SUBJECT: NuScale Power, LLC Response to NRC Request for Additional Information No. 443 (eRAI No. 9450) on the NuScale Design Certification Application

NuScale Response to NRC Request for Additional Information eRAI No. 9450

NRC Question No.: 15.02.07-1

Figure 15.2-33: Steam Generator Inlet Pressure (Typical) - Peak SG Pressure Case (15.2.7 Loss of Feedwater)

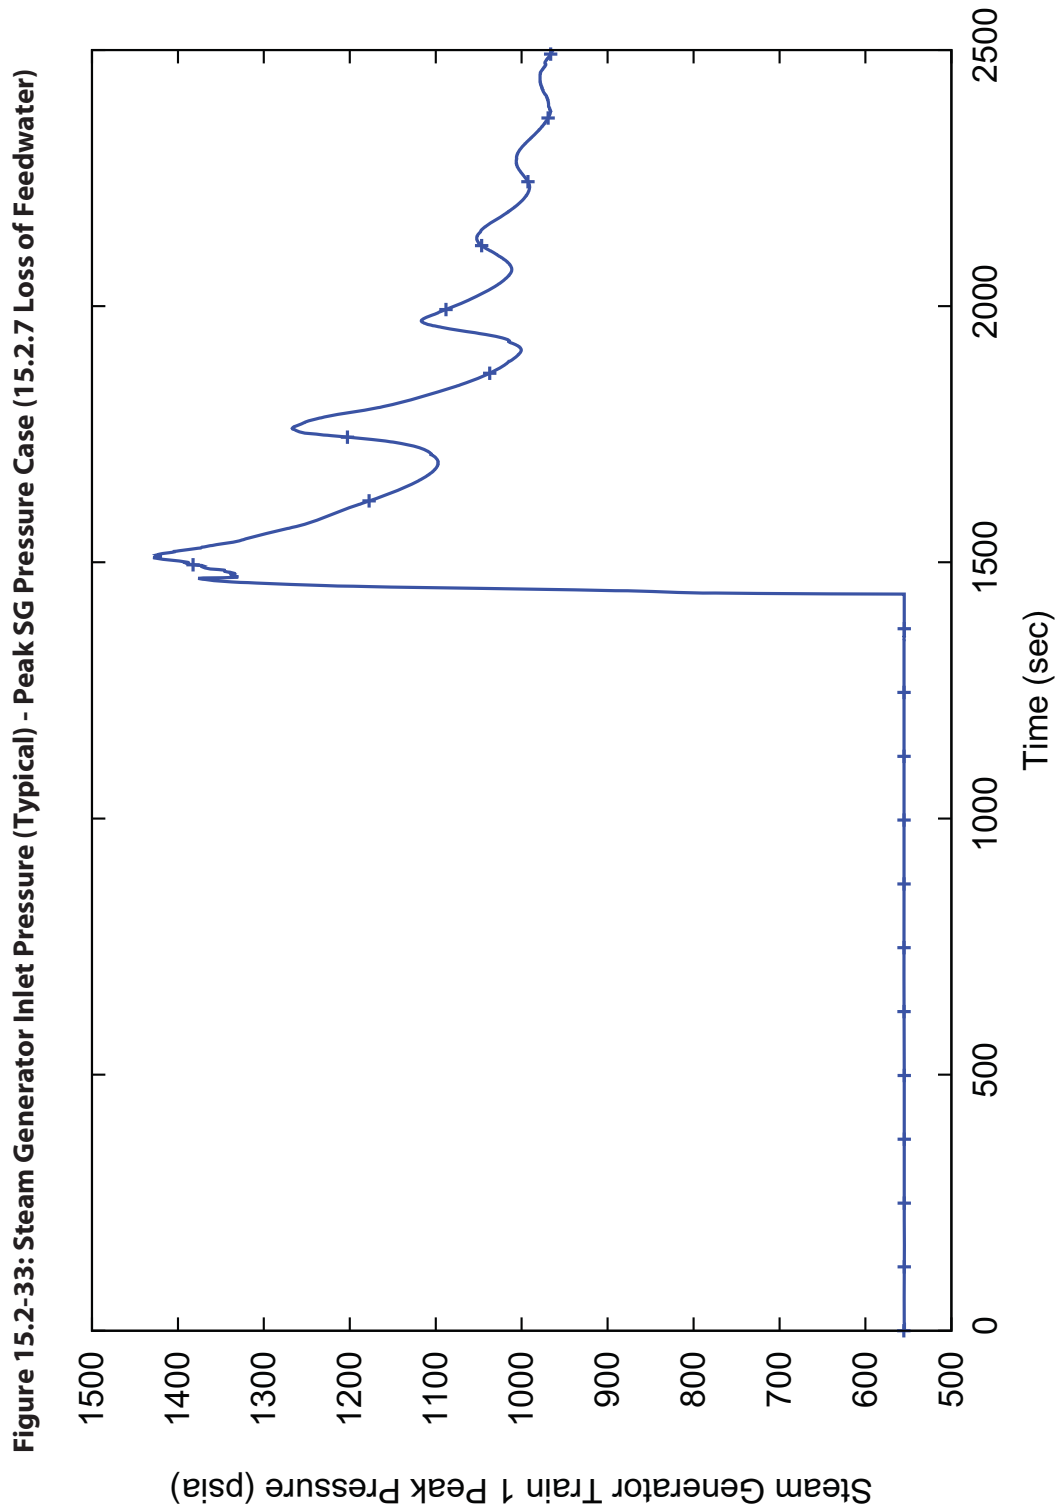
To confirm that the limiting SG pressure event is identified, Case 2 and Case 7 are evaluated with a feedwater flow decrease interval of 0.1 percent. Limiting results are presented in Table 4.

Results from Table 4 indicate that Case 2 yields a more limiting SG pressure than presented in FSAR Section 15.2.7, where the limiting biasing direction changes from low RCS pressure to high RCS pressure. These results are incorporated into FSAR Section 15.2.7 according to the attached markup with a new reported peak SG pressure of 1434 psia.

FSAR Tables 15.2-21, 15.2-22, 15.2-23 and Figure 15.2-33 have been revised as described in the response above and as shown in the markup provided in this response.
